# **Amendment Report**

Licence Number L4404/1991/15

Licence Holder Harvey Fresh (1994) Ltd

Premises Harvey Fresh Dairy and Juice Factories

Figure 1: Current (L4 and L5), previous (L3 and L6) and proposed (L7) wastewater irrigation areas

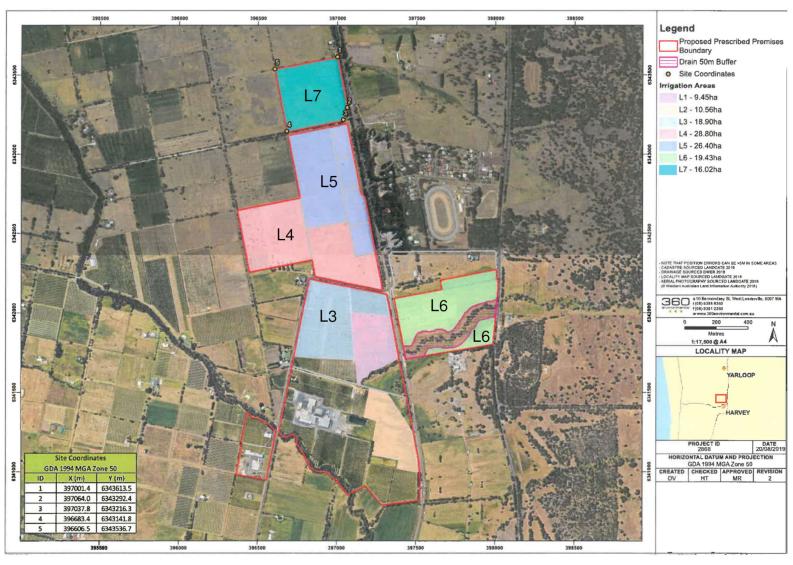
The Licence Holder has applied to add an additional irrigation area totalling 16.02 ha (see Figure 1); L7 being Lot 191 on Deposited Plan 202109 Warrawarrup Road, Harvey.

The Licence Holder has applied to add an additional irrigation area totalling 16.02 ha (see Figure 1); L7 being Lot 191 on Deposited Plan 202109 Warrawarrup Road, Harvey.

Figure 3: Treated wastewater quality from August 2014 to October 2019 for TP (primary axis) and TN (secondary axis)

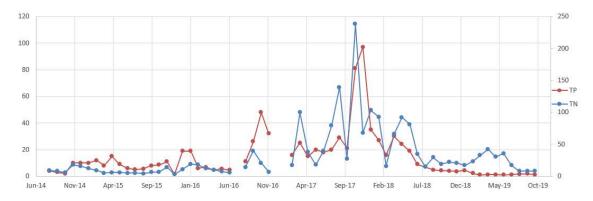
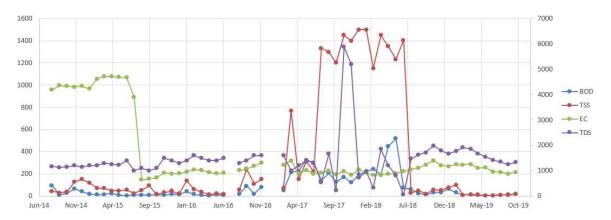
Figure 3 and Figure 4 show fairly consistent results for all parameters until October 2016 when all parameters, except EC, show varied results for the next 21 months. It is noted that from August 2018 to October 2019, all parameters appear to be fairly consistent again and lower (except for TDS and EC) than monitoring between December and July 2018. Table 4 show the range and average treated wastewater quality from August 2018 to October 2019.
